Service Information

Category S	Repair Guidance	Ref. No. R086/10A	Page 1 of 3
Coverage <input type="checkbox"/> Distributor only <input checked="" type="checkbox"/> Please inform your dealers		Date Issued October 29, 2010	
Please convey this information to your <input type="checkbox"/> Director <input checked="" type="checkbox"/> General Manager <input checked="" type="checkbox"/> Warranty Dept. <input checked="" type="checkbox"/> Parts Dept. <input checked="" type="checkbox"/> Training Dept. <input checked="" type="checkbox"/> Field Rep.		Date Revised December 8, 2011	
Applicable Model MX-5/Miata (NC)		Applicable Countries or Specifications Worldwide

Subject: Poor Seat Belt Retraction

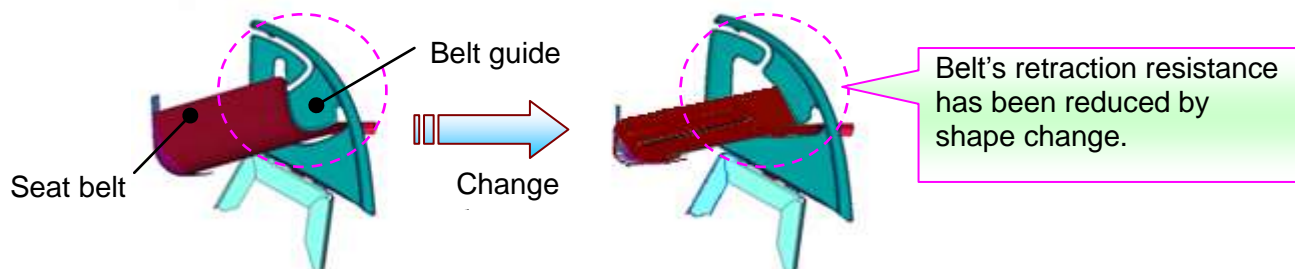
3. Replace the seat belt guide & the protector with the modified ones. (Both Sides)

Note: *The shape of the belt guide (Service parts) has been changed as illustration.

(2) Assembly new seat belt guide & new protector, then install it using original screw.
